re: Grading and Site Servicing Plans Review
Proposed 4-Storey Apartment Building
2928 Bank Street – Ottawa, Ontario

file: PG7073-MEMO.01

Figure 1 - Markup Grading Plan Indicating The Location of Required Insulation for Footings

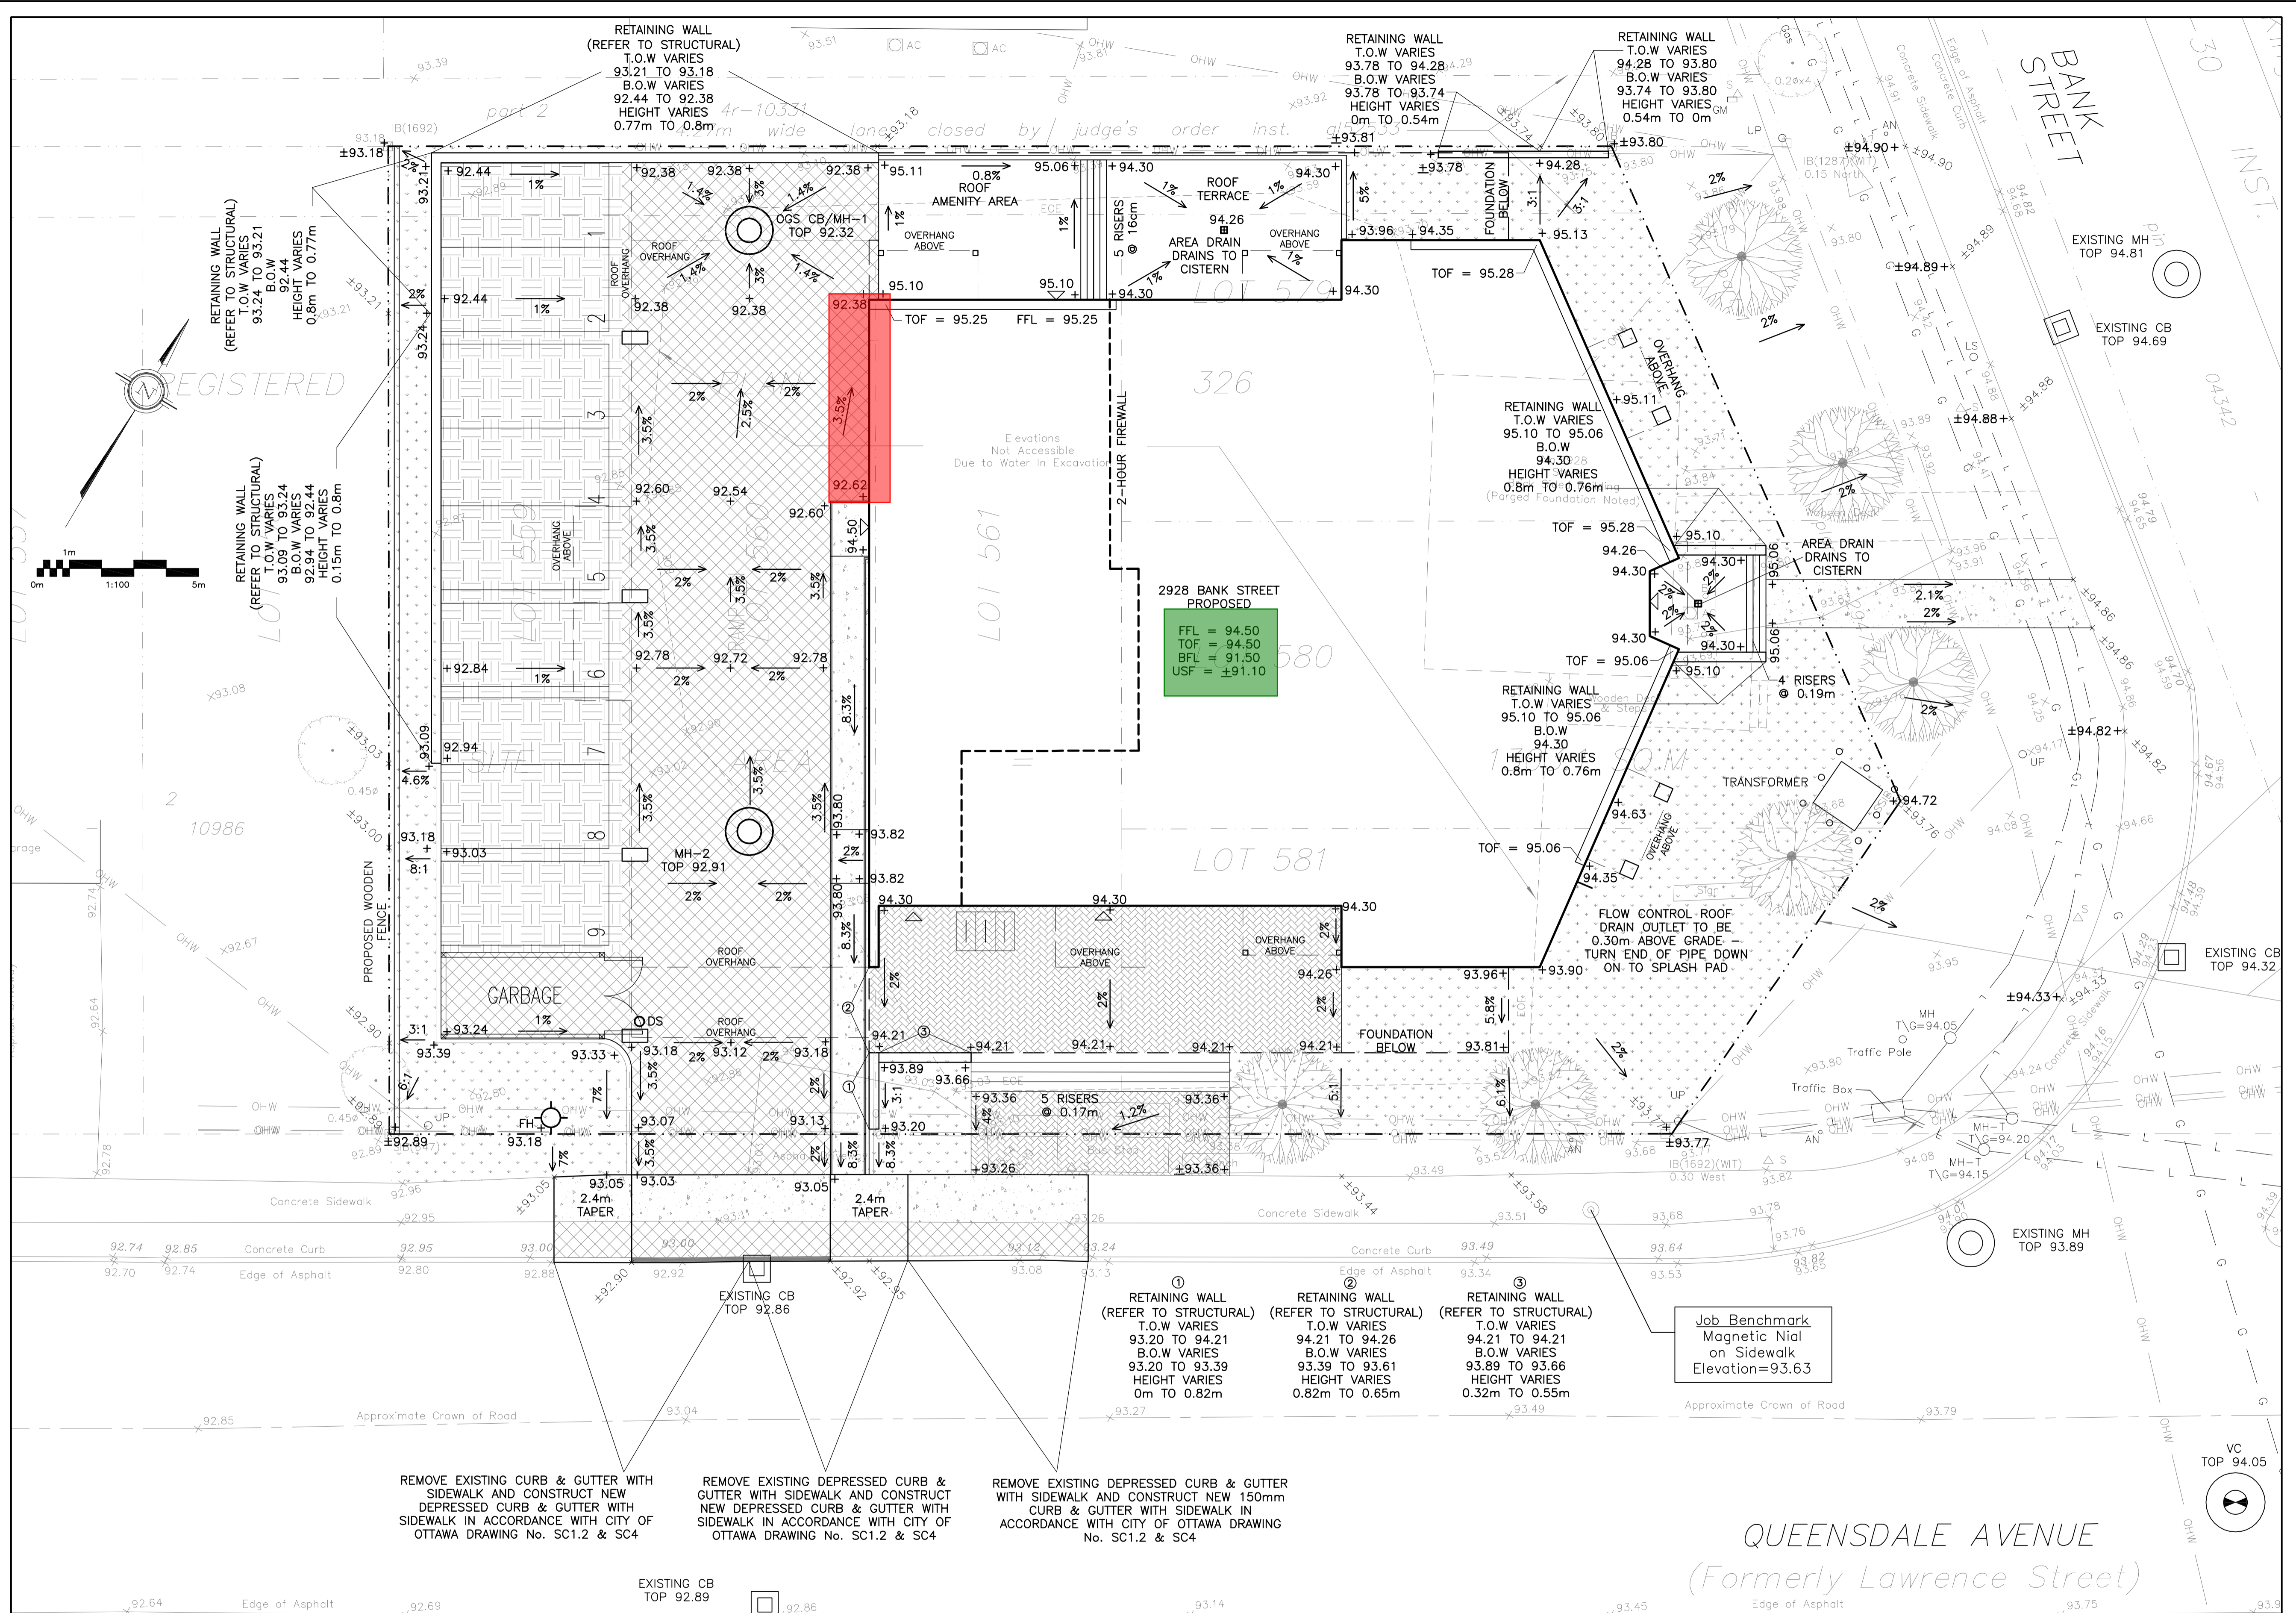
Based on our review of above noted grading plan, it should be noted that some of the perimeter footings for the proposed development are provided by insufficient soil cover. References should be made to Figure 1 – Mark Up Grading Plan Indicating The Location of Required Insulation for Footings.

It should be noted that to accommodate the absence of sufficient frost cover (minimum 1.5 m for heated footings) for the proposed footings, a different form of frost protection should be provided. This can be achieved by means of rigid insulation. Where insufficient soil cover is present above the underside of footings, the rigid insulation recommendations should be followed, as provided in Table 1 in the following.

RIGID INSULATION CONSISTING OF HI40, OR APPROVED EQUIVALENT, BE INSTALLED DIRECTLY BELOW THE PROPOSED FOOTINGS. REFERENCE SHOULD BE MADE TO "PG7073-MEMO.01-TABLE 1" FOR INSULATION DIMENSIONS, INCLUDING THICKNESS.

THE RIGID INSULATION SHOULD EXTEND HORIZONTALLY ON THE EXTERIOR SIDE AND A MINIMUM OF 600 MM HORIZONTALLY ON THE INTERIOR SIDE BEYOND THE FOOTING FACE AND SHOULD CONSIST OF SM RIGID INSULATION. REFERENCE SHOULD BE MADE TO "PG7073-MEMO.01-TABLE 1" FOR INSULATION DIMENSIONS, INCLUDING THICKNESS AND EXTENSION ON THE EXTERIOR SIDE.

Figure 3 - Markup Site Servicing Plan for The Location of Pipes Where Insulation Will Be Required

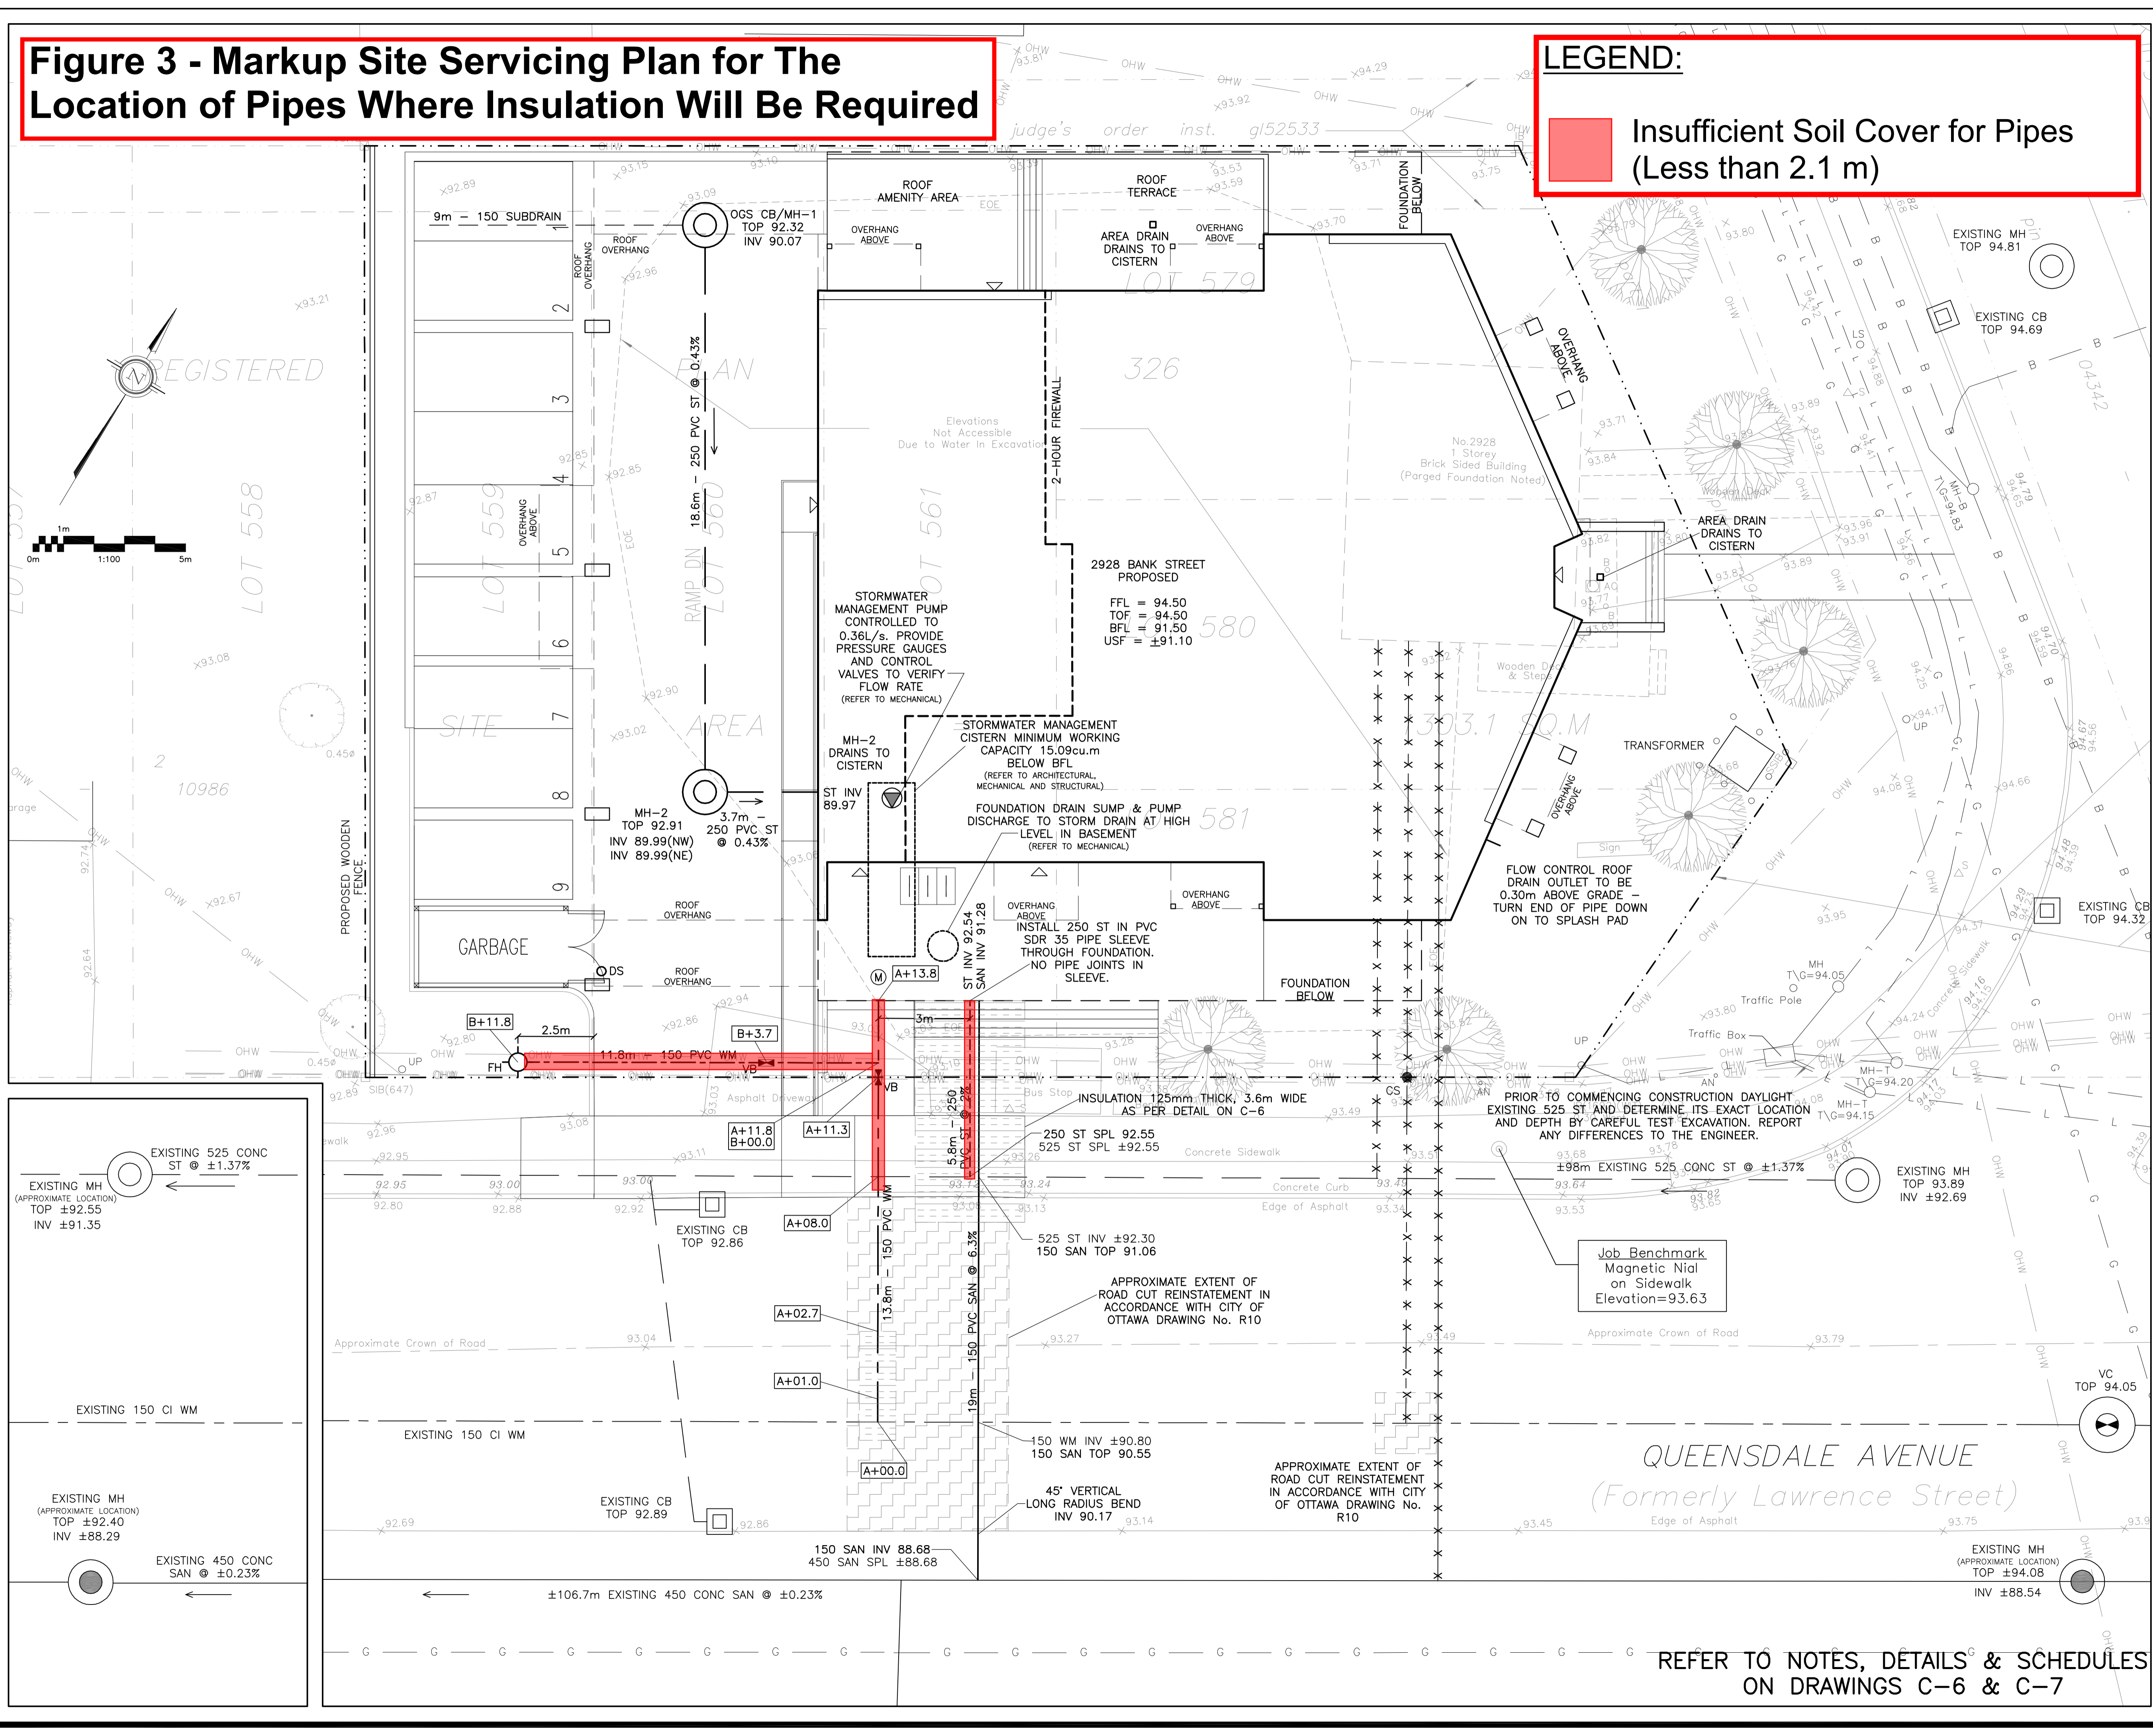
Based on our review of the above-noted site service plan, it should be noted that all services will be constructed outside the lateral zones of the proposed footings of the building and are considered to be acceptable from a geotechnical perspective. However, insufficient frost protection has been provided for the proposed storm sewer pipe throughout the subject site.

Reference should be made to Figure 3 - Markup Site Servicing Plan for The Location of Pipes Where Insulation Will Be Required, attached to this memorandum.

It should be noted that the aforementioned storm sewer pipe is located within the frost zone, approximately within 2.1 m below the finished grade. In the following section, frost protection of the site servicing is recommended where insufficient frost cover has been provided.

Any portion of the services installed at a depth of 2.1 m below the finished grade or deeper is considered to have sufficient soil cover for frost protection. Where insufficient soil cover is present above the invert of storm sewer pipe, the following frost protection criteria should be followed:

Thermal Condition	Soil Cover Provided (mm)	Insulation Dimensions	
		Thickness (mm)	Extension (mm)
Unheated	600 to 900	125	Extend 1200 mm horizontally beyond edge face of the pipe
	900 to 1200	100	Extend 1200 mm horizontally beyond edge face of the pipe
	1200 to 1500	75	Extend 900 mm horizontally beyond edge face of the pipe
	1500 to 1800	50	Extend 600 mm horizontally beyond edge face of the pipe
	1800 to <2100	25	Extend 300 mm horizontally beyond edge face of the pipe
